May 7, 2010

**Re: Responses to NCDWM Questions on  
Potential Remedial Contingencies for Crutchfield Property  
Seaboard Chemical Corp./Riverdale Drive Landfill Site  
Jamestown, North Carolina**

**SCHEMATIC SITE PLAN  
SEABOARD CHEMICAL/ RIVERDALE DRIVE LANDFILL SITE  
JAMESTOWN, NORTH CAROLINA**

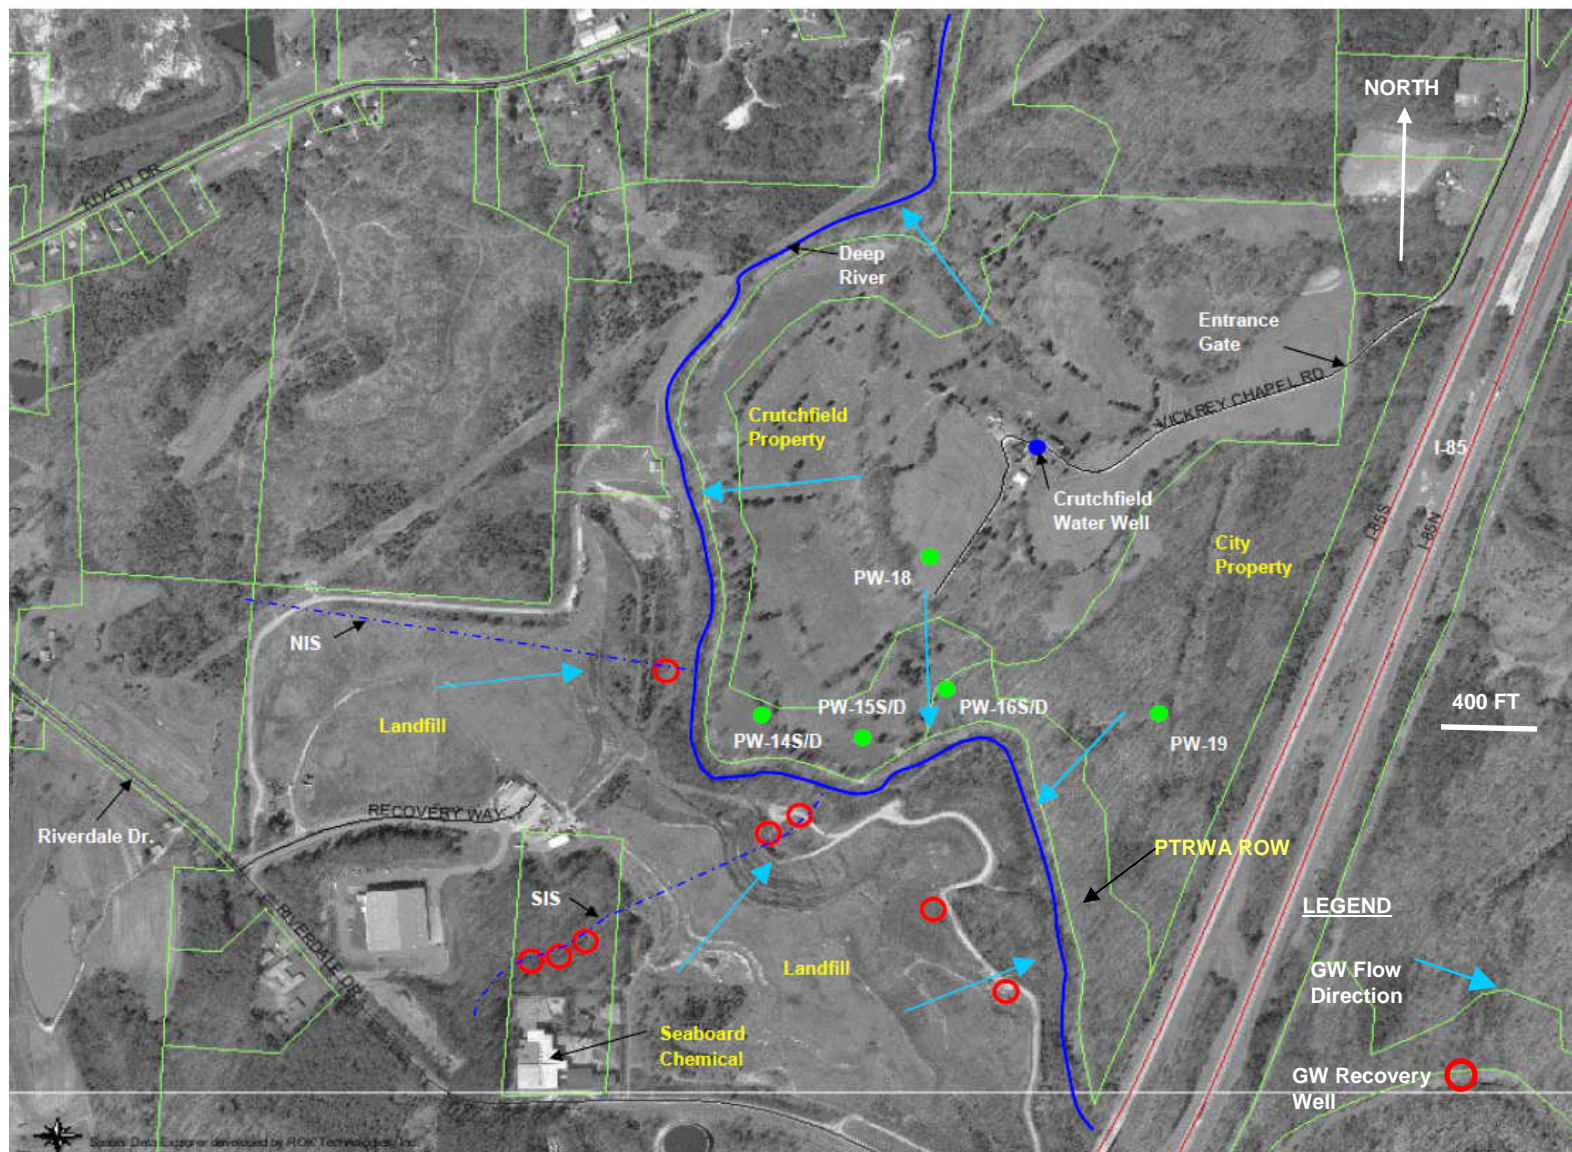
*What happens if the Crutchfield LURs cannot be successfully negotiated?*

2. *What contingencies have you considered?*

We do not believe that any development in the first 200-300 feet of property immediately north of the lake would be possible, because it is owned by the Piedmont Triad Regional Water Authority, and existing restrictions prohibit construction of any dwellings.

We have considered contingencies in the unlikely event that a new water supply well is installed in the future on the southern portion of the Crutchfield property. While possible, we believe that this scenario also is extremely unlikely because of the control that DENR may exert under existing regulations. In particular, 15A NCAC 2C.0107(a)(J) prohibits siting a water supply well within 500 feet of a sanitary landfill, and that eliminates a portion of the Crutchfield property. Also, 15A NCAC 2C.0107(b) prohibits installation of a well intended for domestic use in an aquifer known to be contaminated. We are aware that groundwater beneath at least a portion of the southern portion of the Crutchfield property is contaminated from a source other than the Site.

Nevertheless, if such a well were installed, an enhanced ground water monitoring program may be warranted to evaluate potential effects on ground water flow and plume containment that may be caused by the ground water withdrawal from the new well. If the enhanced monitoring results indicate that the pumping of the new water well is causing affected ground water to migrate toward the Crutchfield property, then the DENR would be notified and termination of pumping would be recommended.
